Subject OPOG Responses to EPA 2-8-06 MIP/SVS Comments

Responses to EPA Comments Dated February 8, 2006
On-Site Soils RI/FS Work Plan Addendum No. 2
Summary of Initial Findings from Soil Vapor and MIP Sampling
(CDM, January 27, 2006)

Figure 5. PCE (mg/m³) 15 – 30 feet bgs

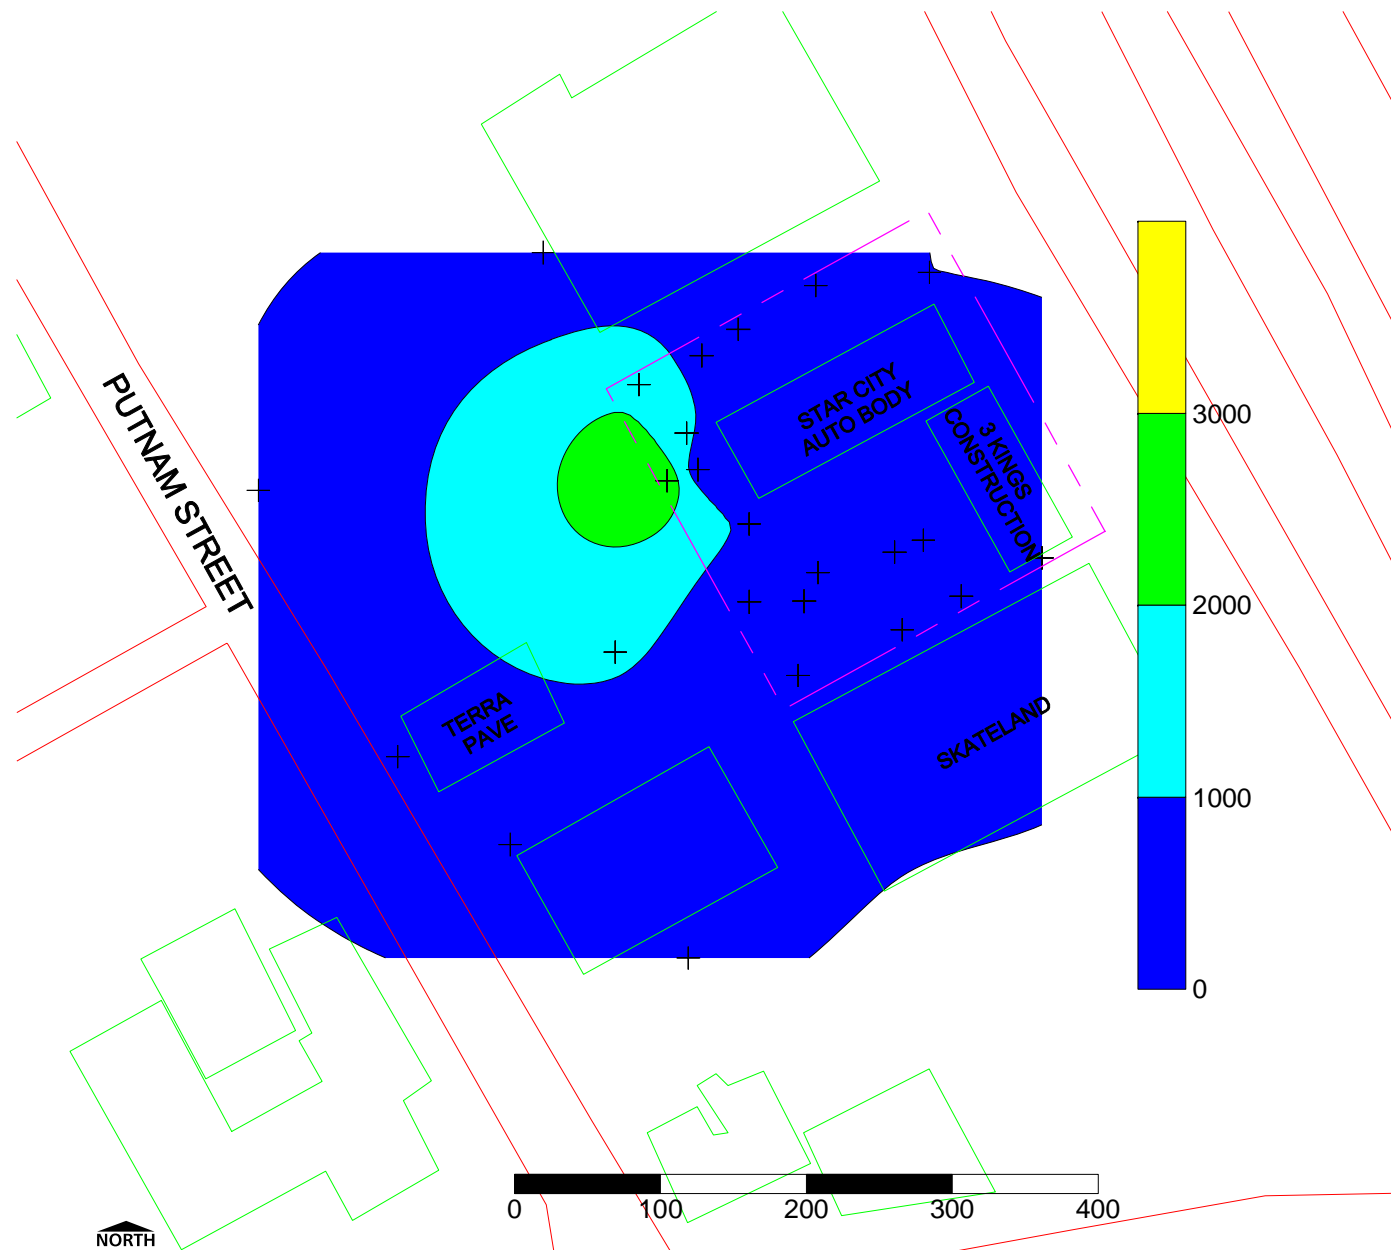
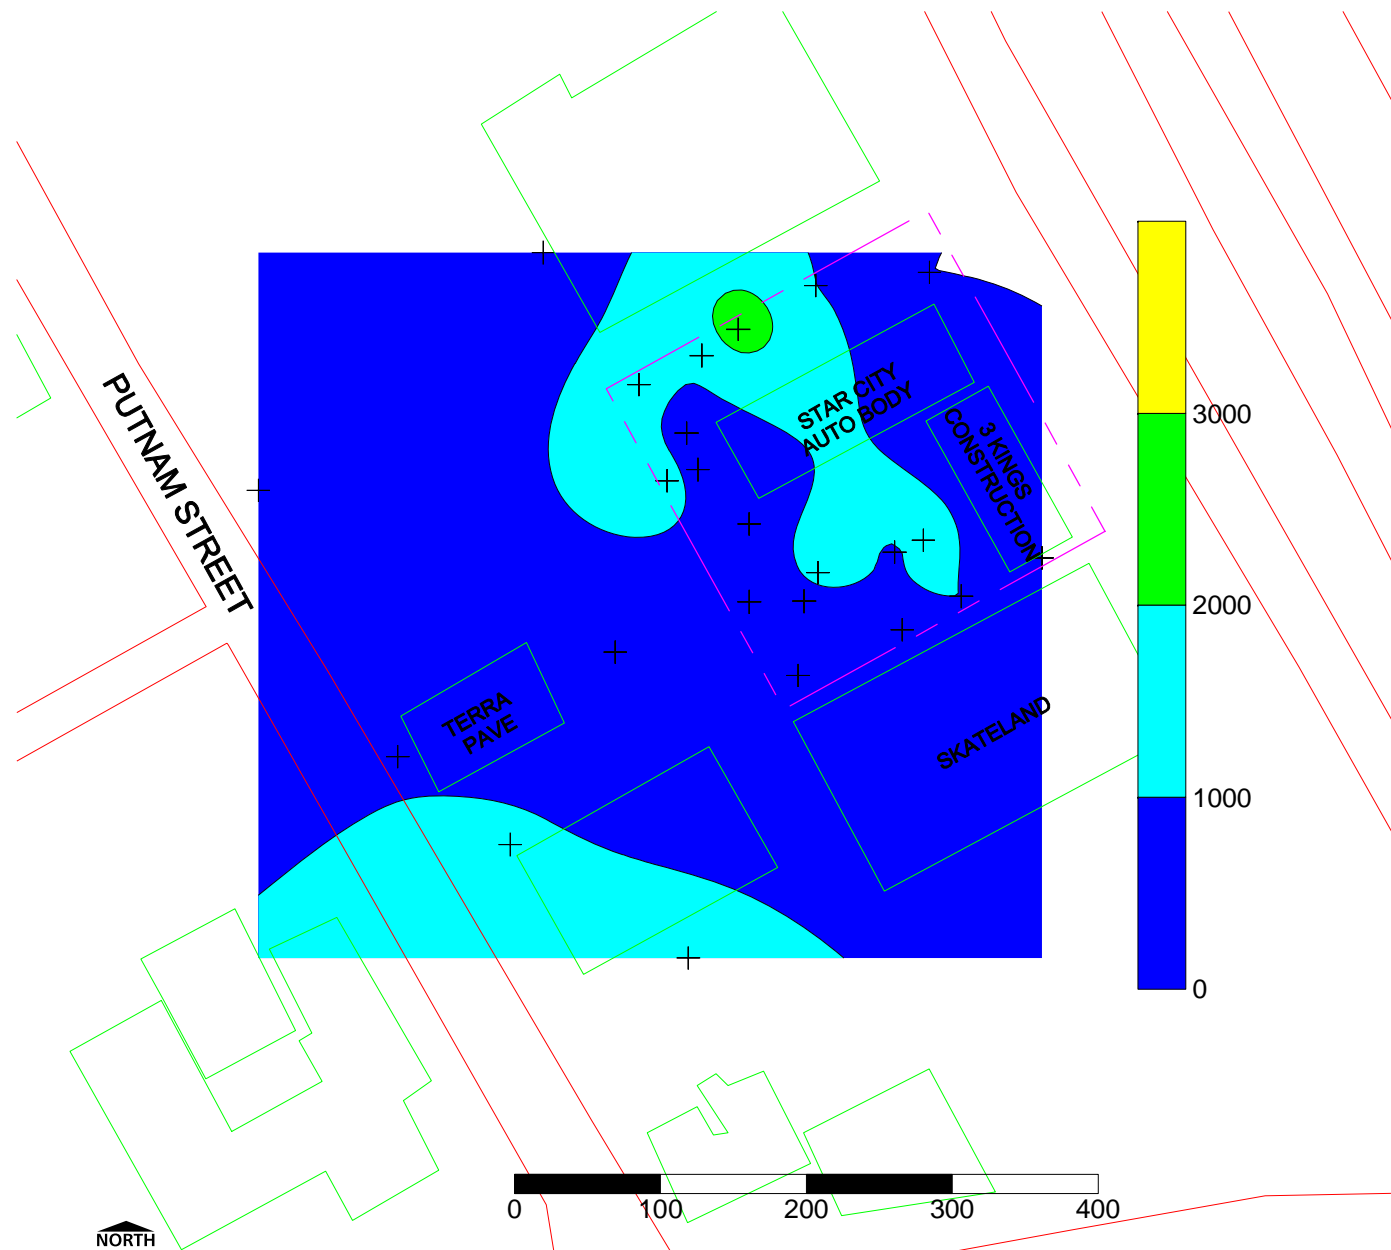
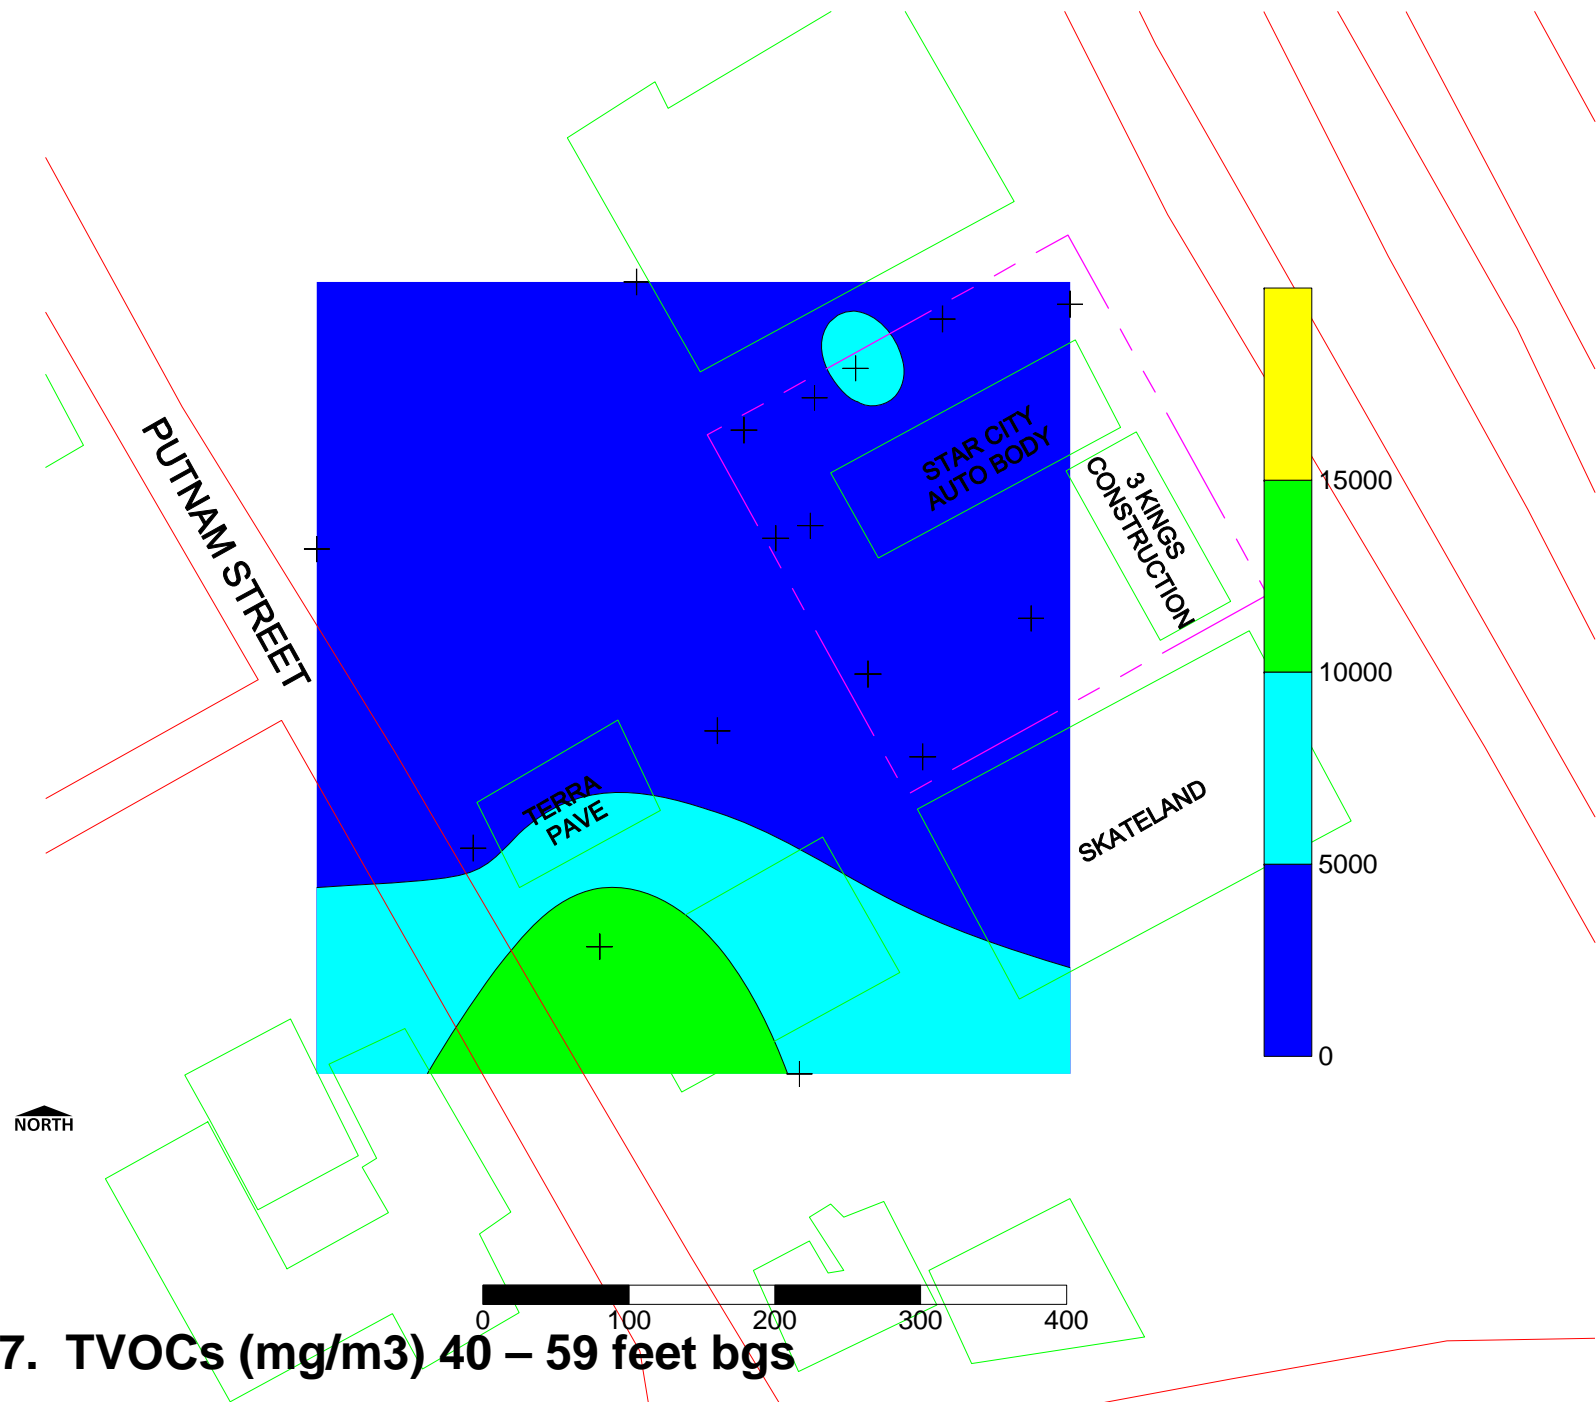
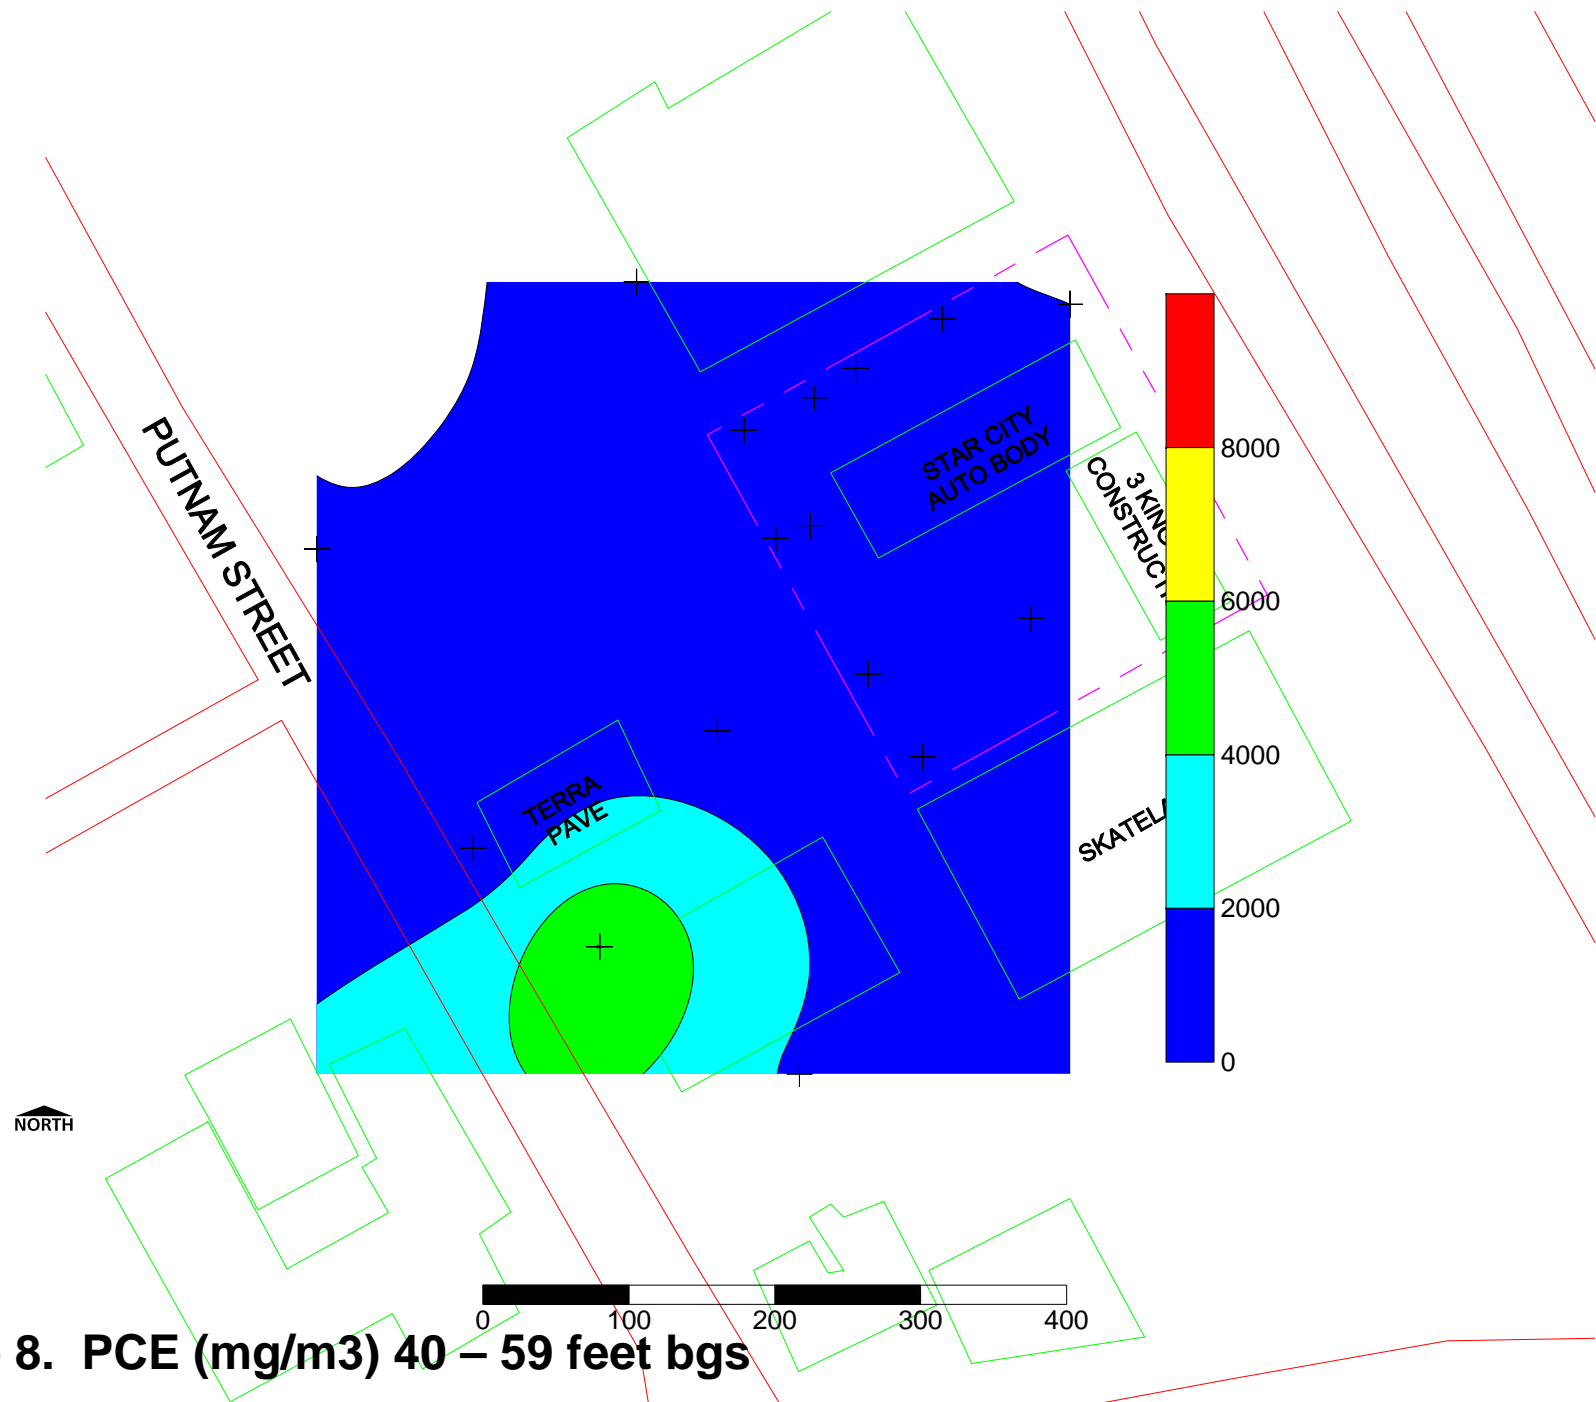
8. Prepare contour maps for total VOCs, PCE, and Freon 113 (plus any other compounds that OPOG/CDM selects) in addition to the pie chart maps (Figures 19 to 22). The contours will indicate potential source areas as well as locations where additional sampling is needed.

Response: Contour maps have been prepared and are provided in the attached PowerPoint file.
